## HISTORIC AND DESIGN REVIEW COMMISSION

August 2, 2023

**HDRC CASE NO:** 2023-286  
**ADDRESS:** 2030 W MULBERRY AVE  
**LEGAL DESCRIPTION:** NCB 1952 BLK 20 LOT 21  
**ZONING:** R-6, H  
**CITY COUNCIL DIST.:** 7  
**DISTRICT:** Monticello Park Historic District  
**APPLICANT:** Jerry Woolf | J.B. Woolf Sheds  
**OWNER:** Robert Chalk  
**TYPE OF WORK:** Construction of a garage structure  
**APPLICATION RECEIVED:** July 7, 2023  
**60-DAY REVIEW:** September 5, 2023  
**CASE MANAGER:** Bryan Morales

### REQUEST:

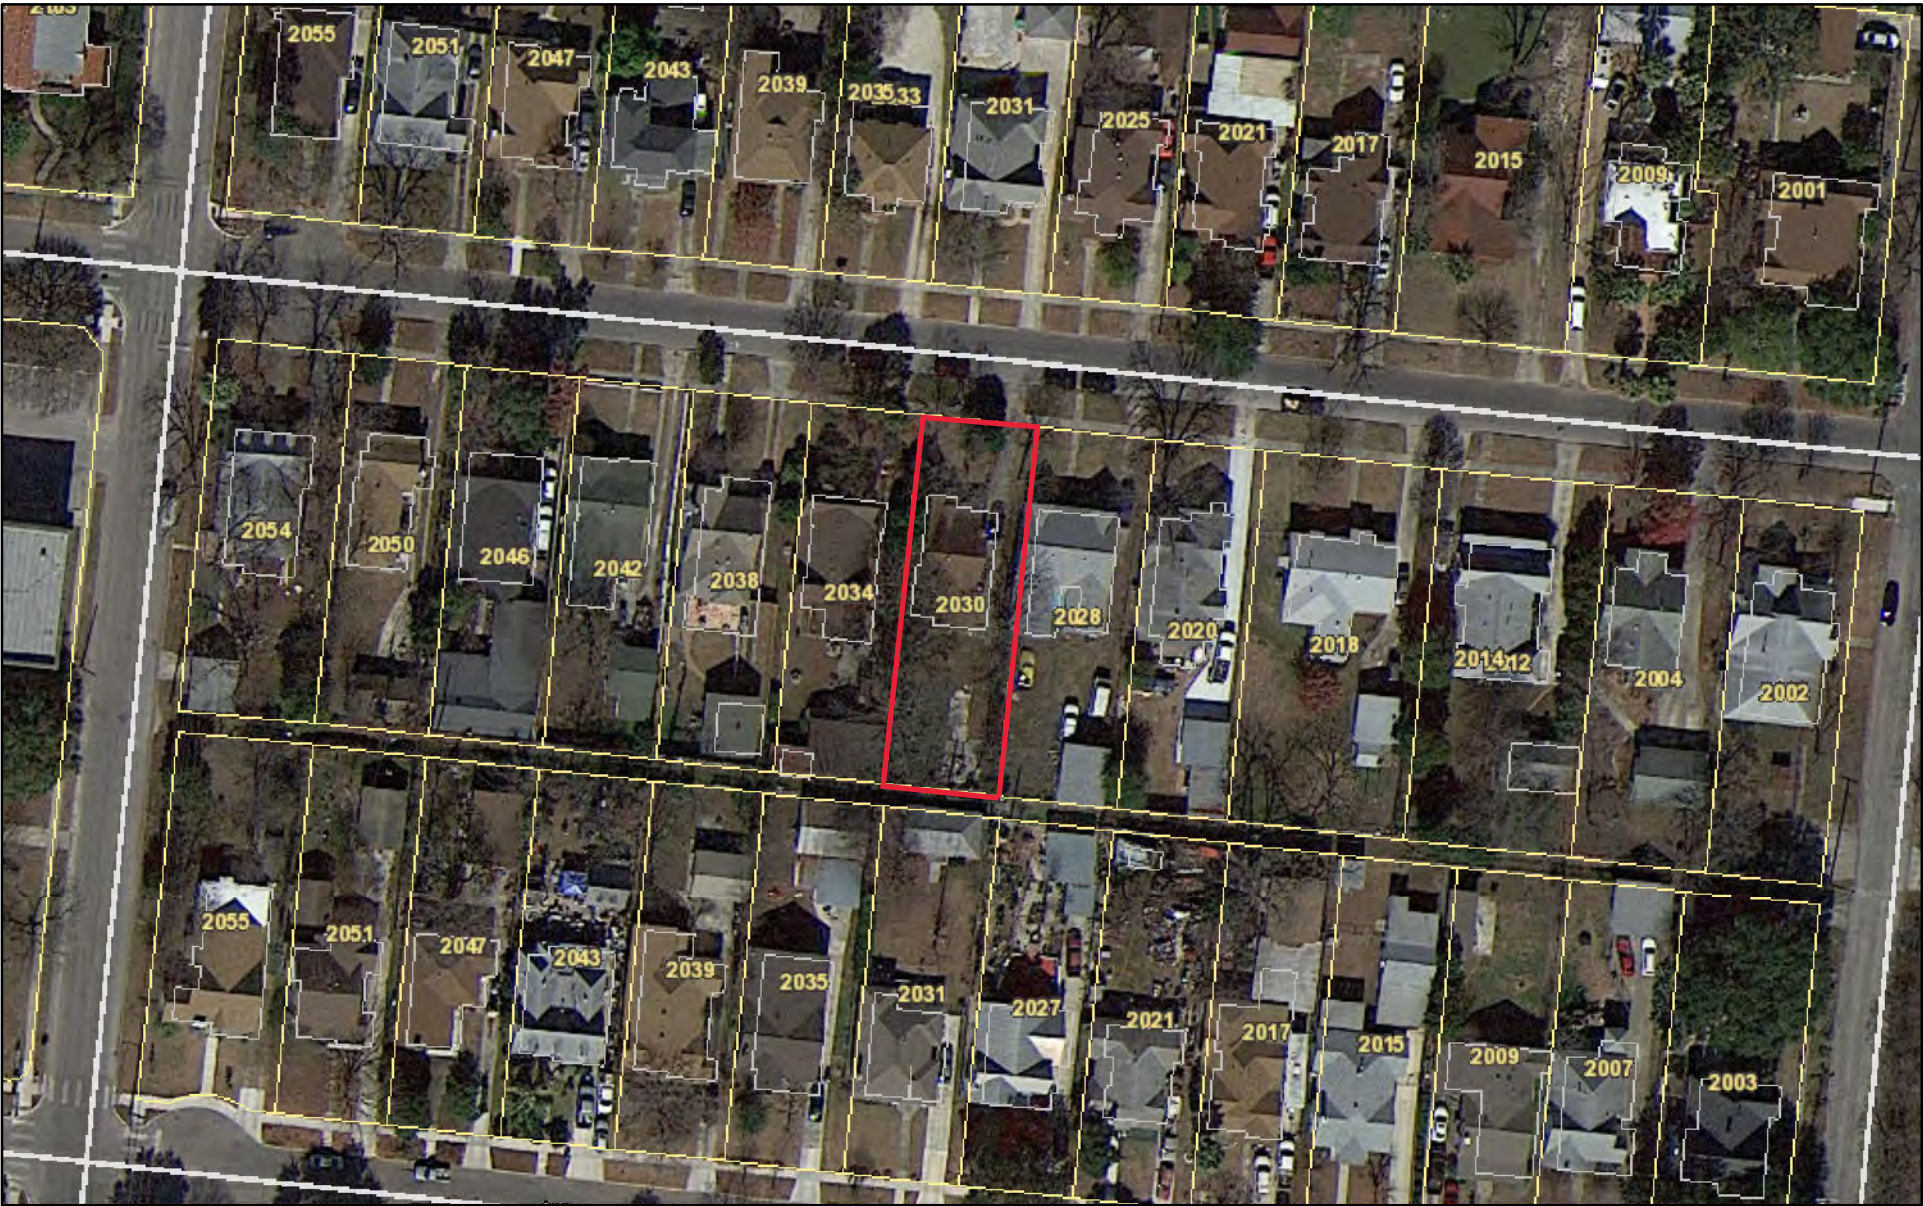
- b. **NEW CONSTRUCTION (ACCESORY STRUCTURE)** – The applicant is requesting to construct a one-story, split-bay detached garage at the rear of the property. The Guidelines for New Construction 5.A. notes that new garages and outbuildings should be visually subordinate to the primary historic structure in terms of their height, massing, and form, and should be no larger in plan than forty percent of the primary historic structure’s footprint. The existing primary structure on the lot features a footprint of 1,672 square feet and one story in height. The proposed one-story accessory structures feature a total footprint of approximately 576 square feet, or approximately 34% of the primary structure’s footprint. Accessory structures on the block are predominately single story in the neighborhood. Staff finds the proposed height and general massing conforms to guidelines.

ELEVATIONS

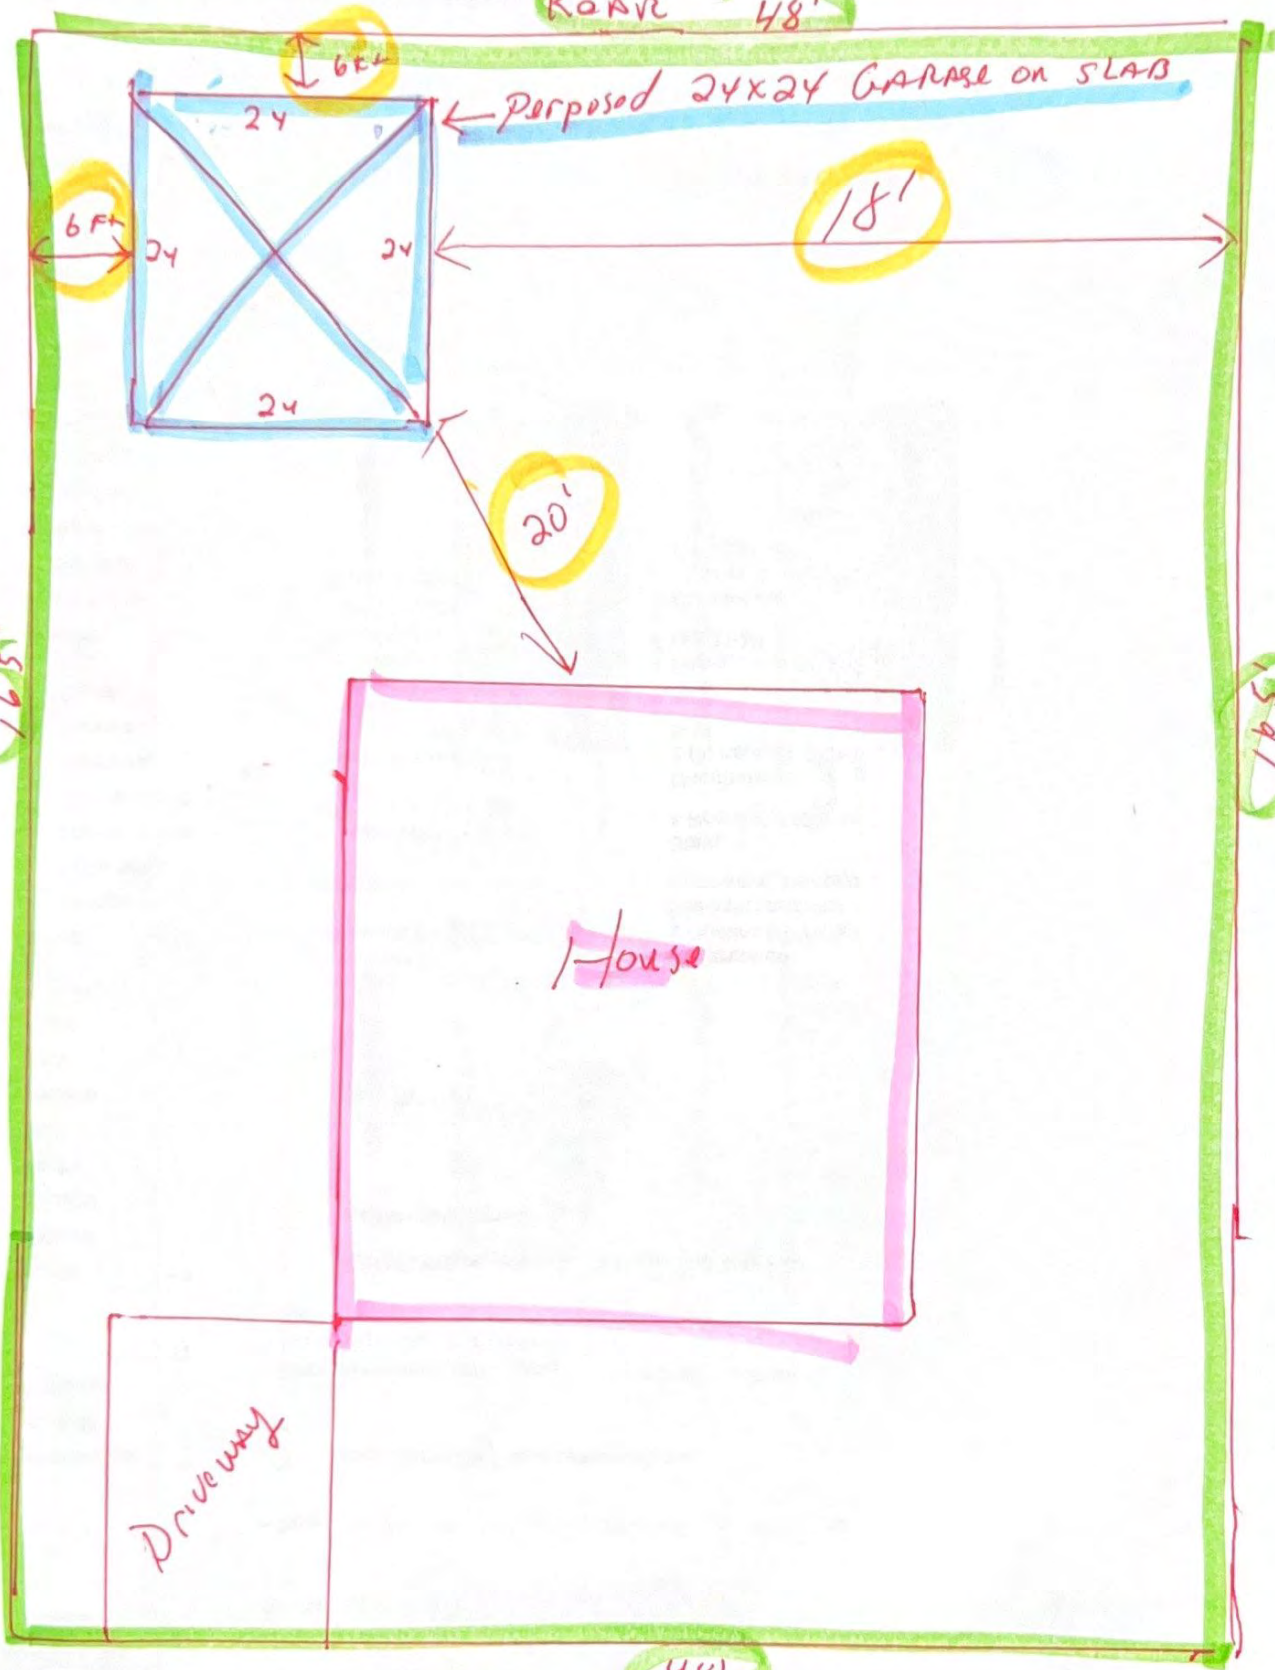
- e. **ARCHITECTURAL DETAILS (FENESTRATION PATTERN)** – The applicant is proposing to install a split-bay garage door on the front-facing elevation and a door on the side elevation. The Guidelines for New Construction 2.C.i. related to window and door openings stipulates to incorporate window and door openings with a similar proportion of wall to window space as typical with nearby historic facades. Staff finds the proposed fenestration pattern generally conforms to guidelines.

- i. That the applicant install a fiber cement board that features a reveal no more than 6 inches and a smooth finish.
- ii. That the applicant install a garage door that uses wood as the primary material or have the appearance of wood.
- iii. That the applicant abide by all setback requirements.
